REMARKS

I. Status of the Application

The status of the Subject Application is as follows: Claims 1-78 are pending in the Subject Application. Claims 1-8, 13-23, 40, 47-55, 61, and 65-73 stand rejected by the Official Action under 35 U.S.C. § 112, second paragraph. Claims 9-12, 24-39, 41-46, 56-60, 62-64, and 74-78 have been withdrawn from consideration pursuant to Applicant's election without traverse of claims 1-8, 13-23, 40, 47-55, 61, and 65-73 in its response to the action of March 26, 1999.

FIG. 1

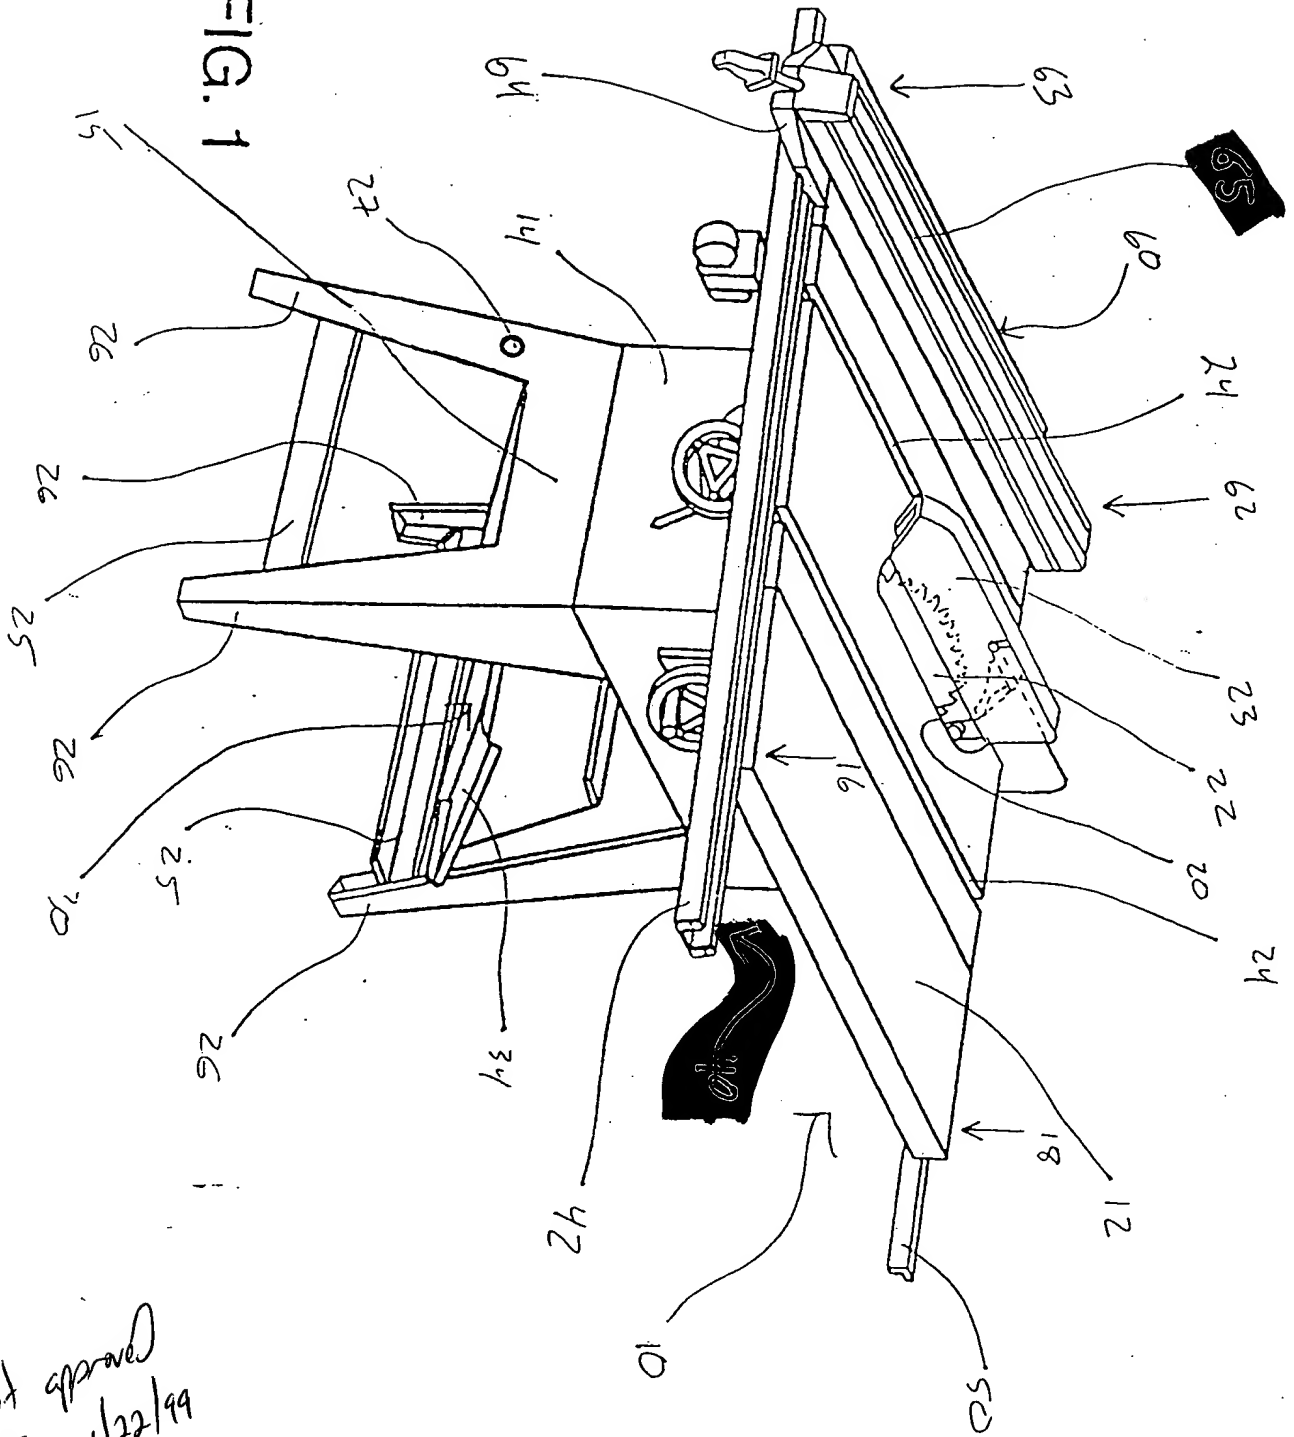
The drawings have been objected to under 37 C.F.R. § 1.83(a). In particular, the Official Action asserts that, "[i]n Figures 1 and 2, the occurrence of '62' with the arrowhead lead line appears to be inaccurate, and it seems that it should be changed to --65-- since it represents the outfeed end (opposite which represents the infeed end)." Responsive to this objection, Applicant respectfully requests replacement of original Figures 1 and 2 with replacement Figures 1 and 2 which depict, in pertinent part, the arrowhead lead line labeled "62" in the original drawings as "65".

FIG. 13

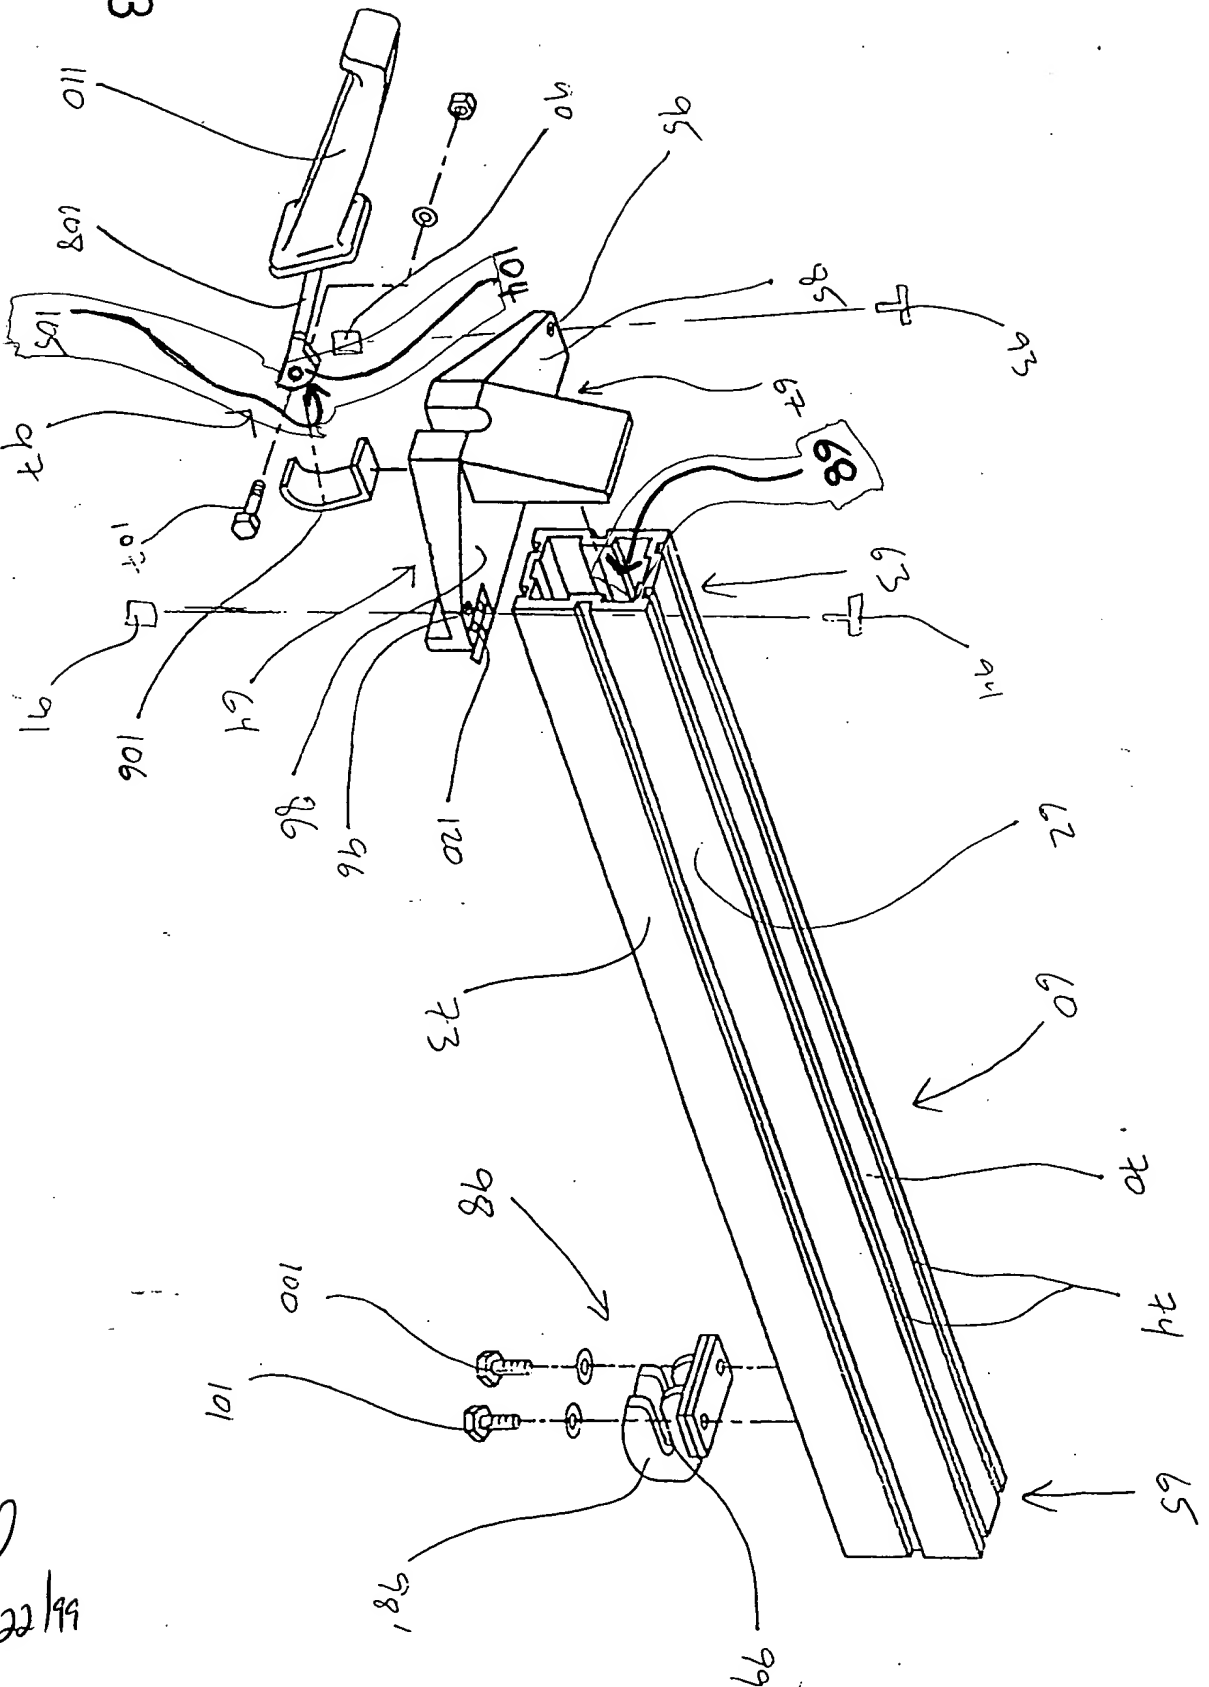
In addition, the Official Action asserts that, "[i]n Figure 13, '105' appears to be inaccurate, and it seems that it should be changed to --104-- and --105-- should be added with a lead line extending to the rounded cam surface of clamp 104 to correspond to the specification

(e.g., see page 22, line 6); also, it seems that '104' along with its lead line should be deleted for clarity; further, it seems that --68-- with a lead line extending to the inner region at the infeed end 63 of body 62 should be added for clarity." Responsive to this objection, Applicant respectfully requests replacement of original Figure 13 with replacement Figure 13 which depicts, in pertinent part, "105" with a lead line extending to the rounded cam surface of clamp 104, "104" with a lead line extending to clamp 104, and "68" with a lead line extending to the inner region at the infeed end 63 of body 62.

FIG. 15

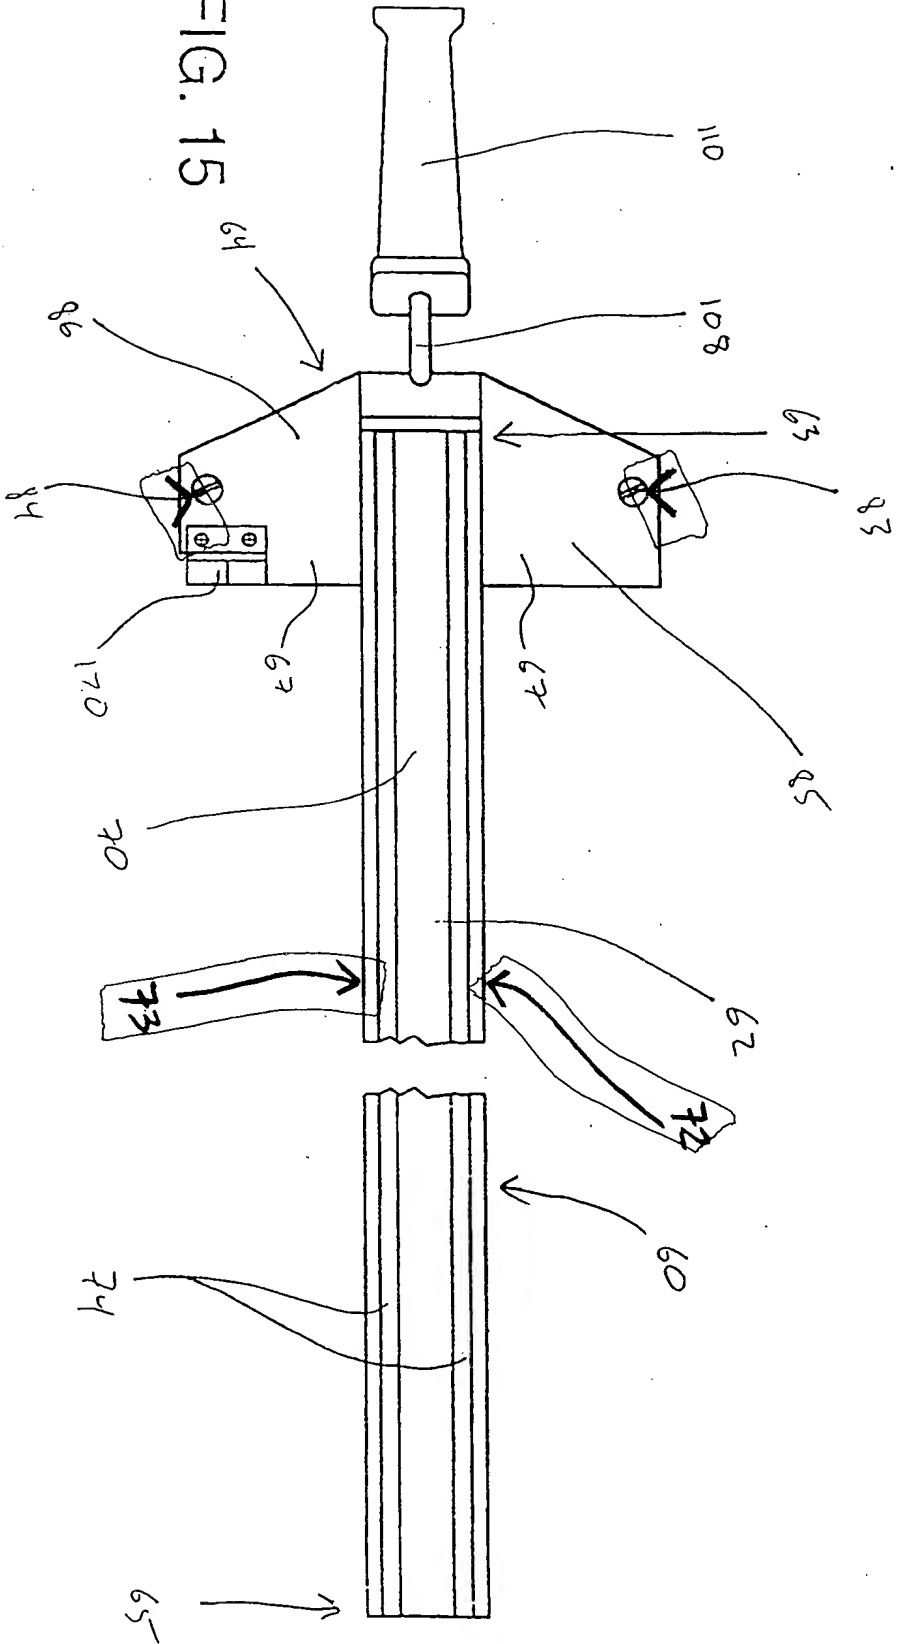
Further, the Official Action asserts that, "[i]n Figure 15, numerals --72-- and --73-- should be added for clarity; further, the lead line for each of numerals 83 and 84 should end in an arrowhead since these numerals generally represent a height adjustment mechanism." Responsive to this objection, Applicant respectfully requests replacement of original Figure 15 with replacement Figure 15 which depicts "72" and "73" with lead lines extending to the side faces of the body 62 and the lead lines labeled "83" and "84" ending in an arrowhead.
